Modification to Approved Project

City of Rochester, New Hampshire

Case #137-35-1-HC-21 Property Address29 Wadleigh Road, Rochester, NH						
Type of project: Site Plan; Subdivision; Line Adjustment; Other _X						
Original Project Description: 52 unit market-rate apartment building at 29 Wadleigh Road						
Date of original Planning Board approval April 4, 2022						
Description of modification: Changing 52 unit Market-Rate apartment building into 52 unit affordable apartment building; see owner-provided narrative for all building and site alterations as part of changing product type

RE: Wadleigh Road Apartments | Rapids at Cocheco – Building Plan Change Narrative

C3

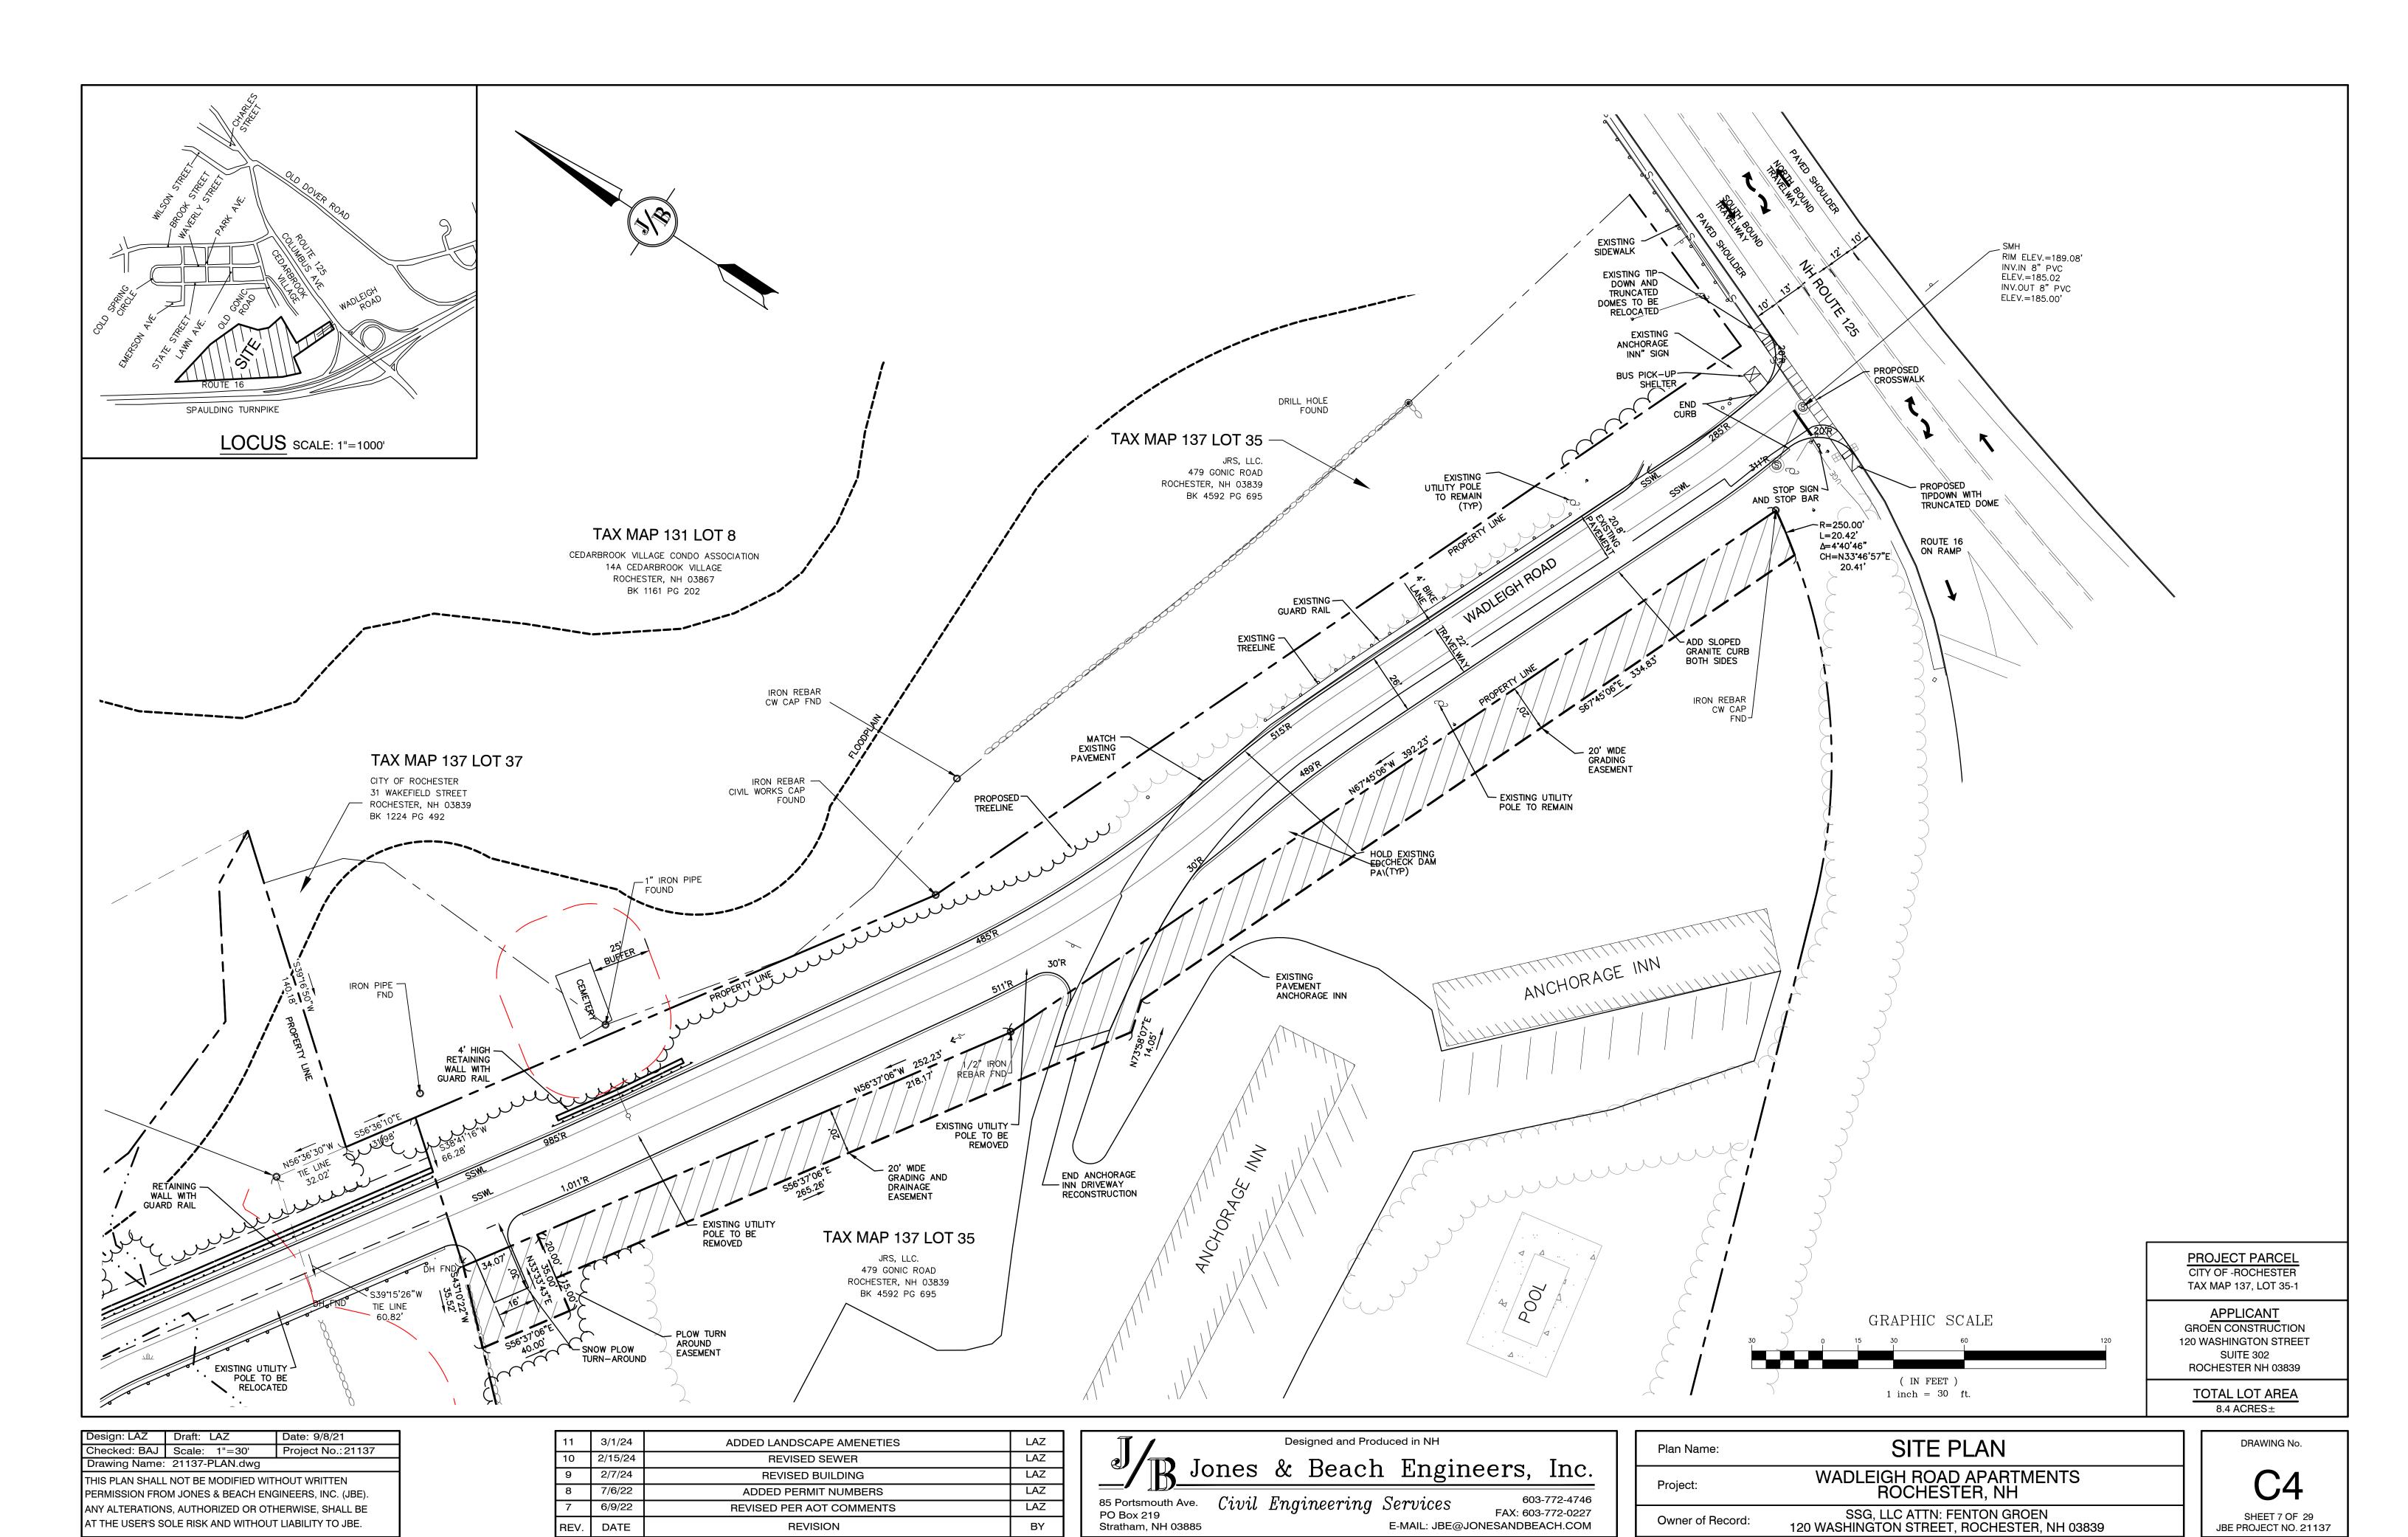
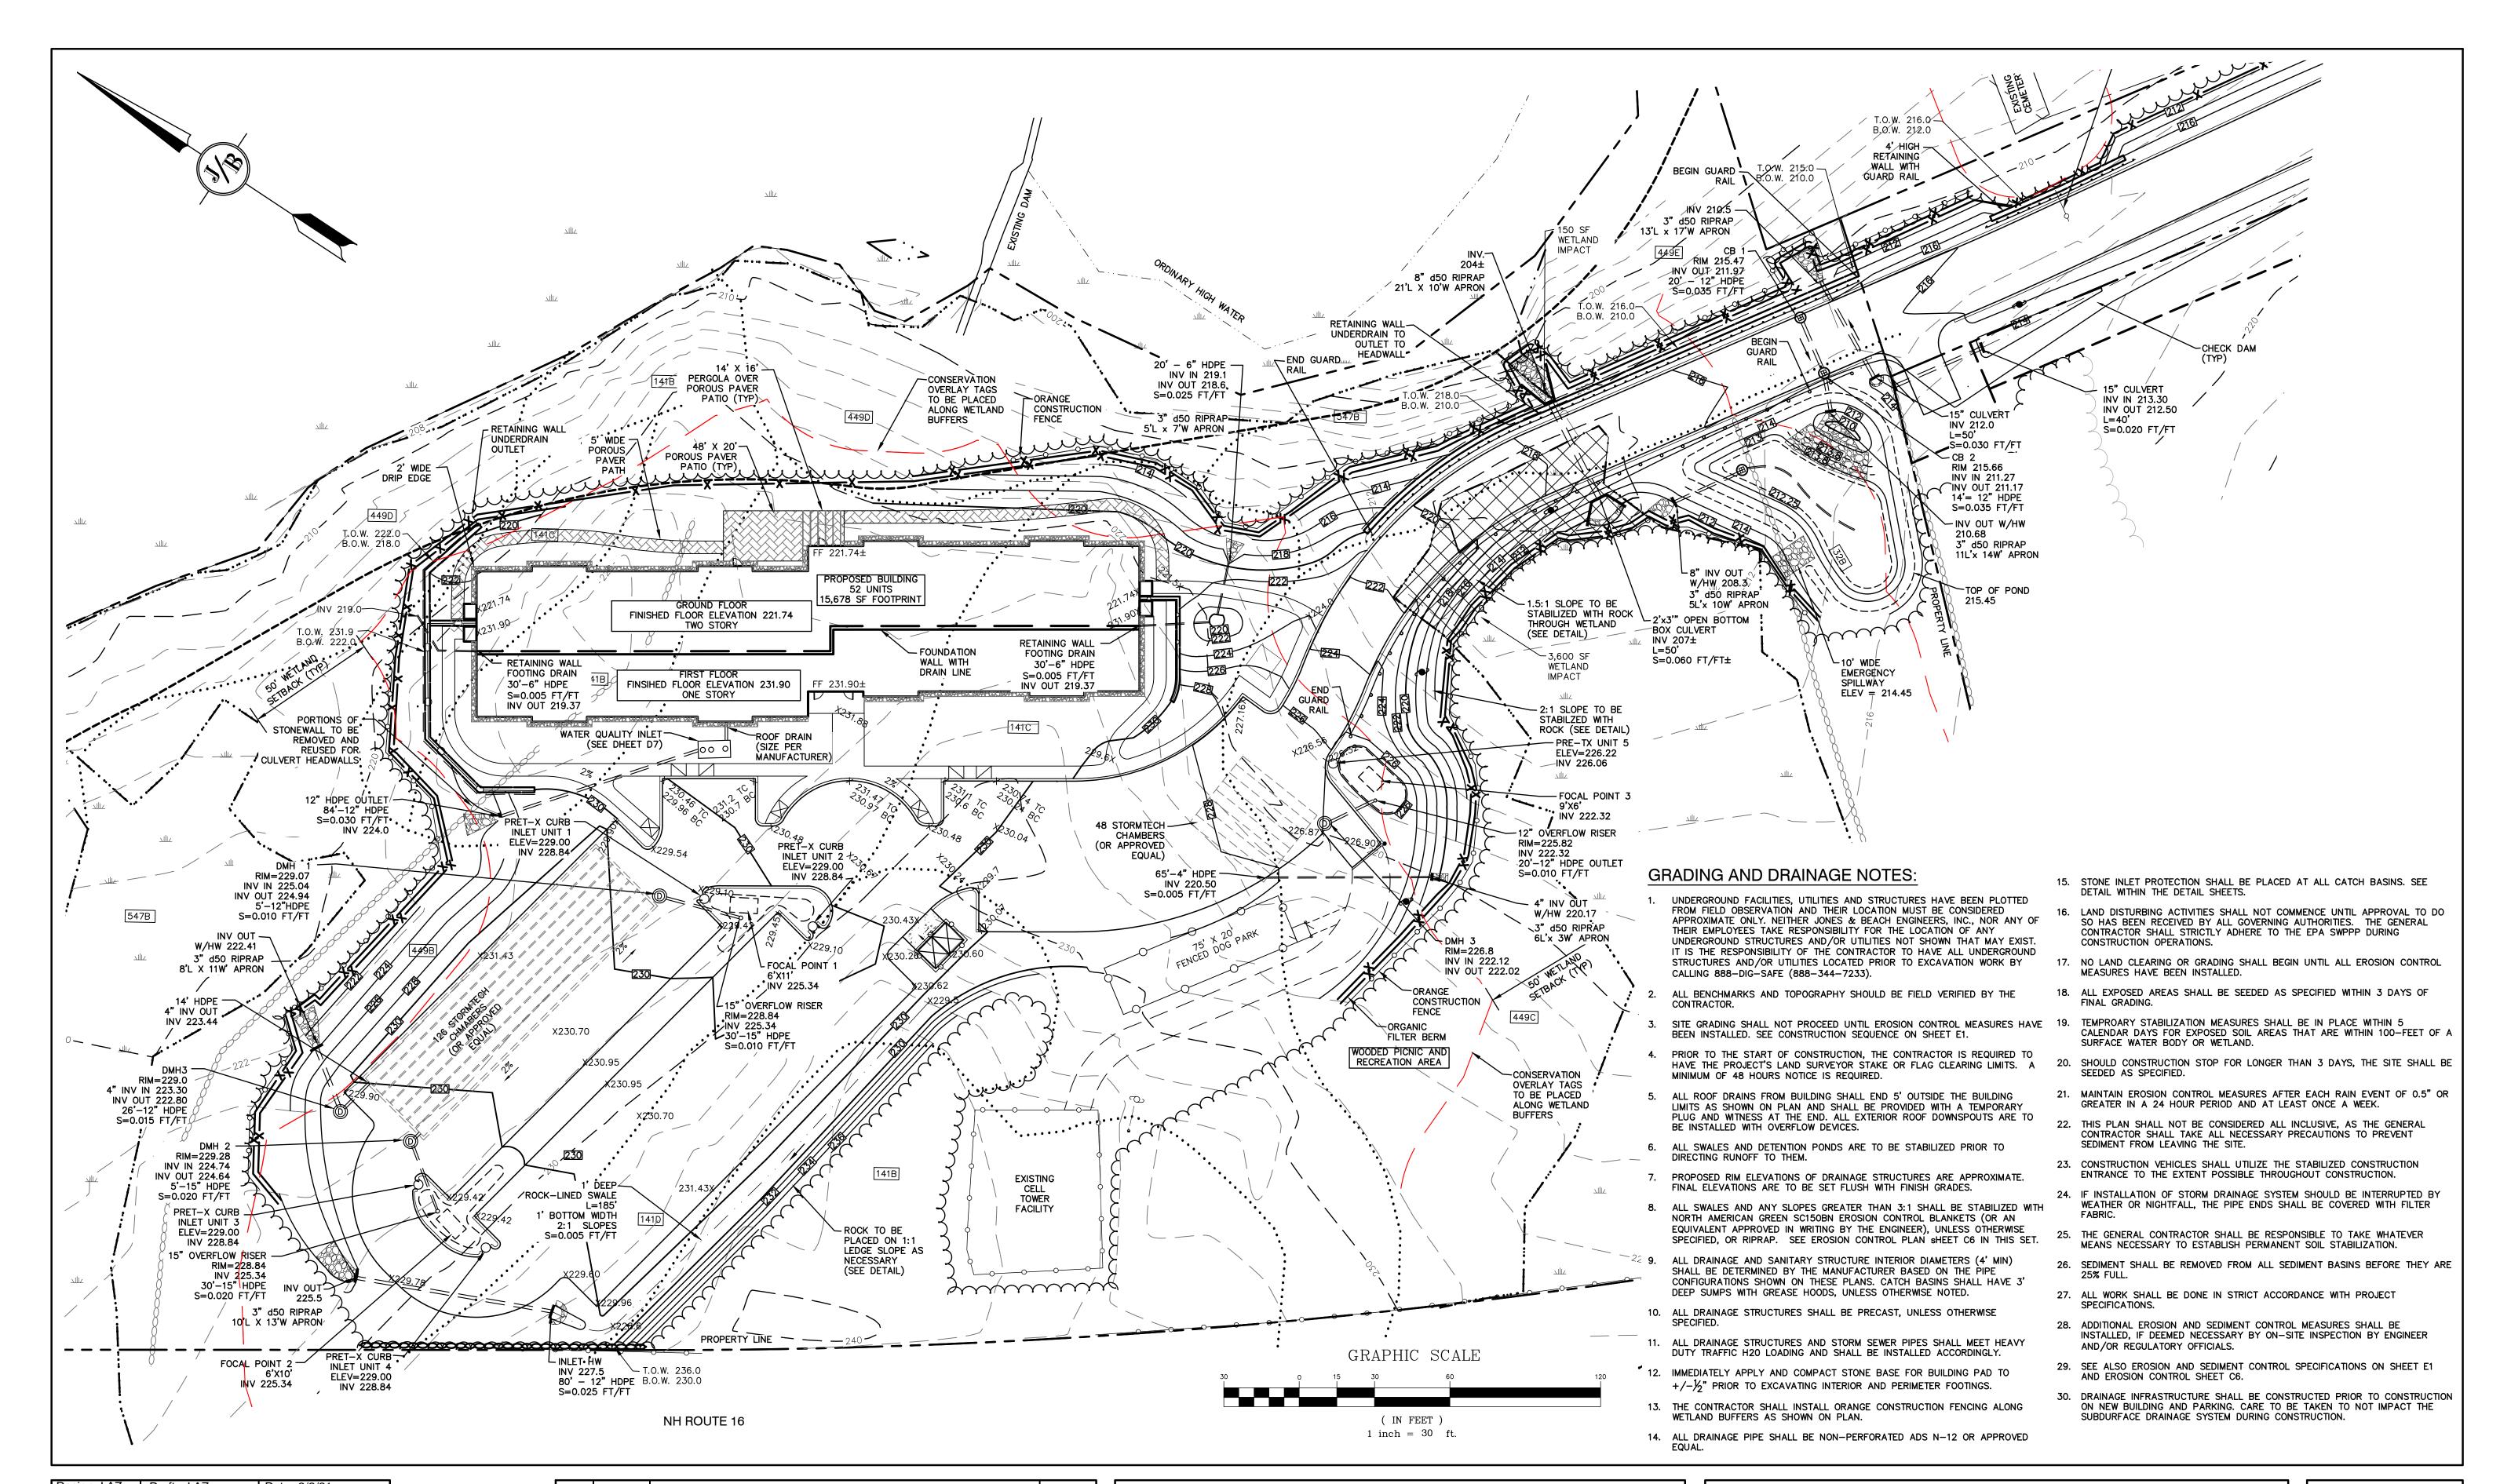
The footprint changes (indicated in the attached exhibit – see sheet C3) are primarily programmatic changes from the market rate apartments to the affordable apartments.

Reductions in the footprint range from 2.7 feet up to over 16 feet depending on the location (exhibit sheet C3); overall length of the building has been reduced by approximately 10 feet. The building height is reduced from a peak of 37'-10" to 32'-10" (see attached elevations for approved building heights compared to the new building height).
